December 4, 2012

Whitman Town Hall Accessibility Survey

Conducted by the Massachusetts Office on Disability

November 19, 2012

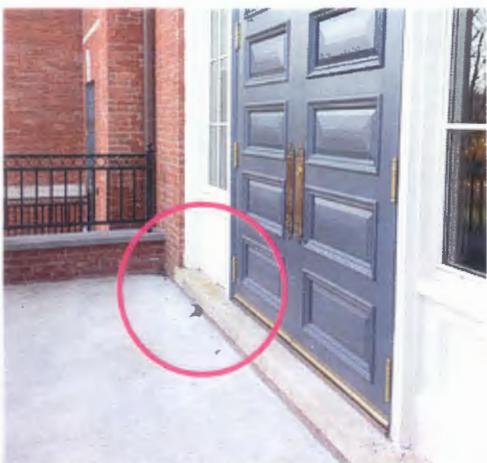
<p><i>Vertical Access/South Entrance</i> There is no vertical access provided at the south entrance as shown on page 2, entrance summary.</p>			
<p><i>Signage/East Entrance</i> The existing sign which reads, "PLEASE USE HANDICAP ENTRANCE AFTER 4:00PM", is not placed with the language or intent of guiding one to an accessible entrance. The sign cannot be read from the bottom of the stair.</p>	<p>25.6 SIGNAGE Any <i>entrance/exit</i> of a <i>facility</i> not <i>accessible</i> by persons in wheelchairs shall have a sign clearly indicating the location of the <i>accessible entrance/exit</i>.</p>		
<p><i>Signage/West Entrance</i> There is no sign indicating where the accessible entrance to the building is located.</p>	<p>25.6 SIGNAGE Any <i>entrance/exit</i> of a <i>facility</i> not <i>accessible</i> by persons in wheelchairs shall have a sign clearly indicating the location of the <i>accessible entrance/exit</i>.</p>
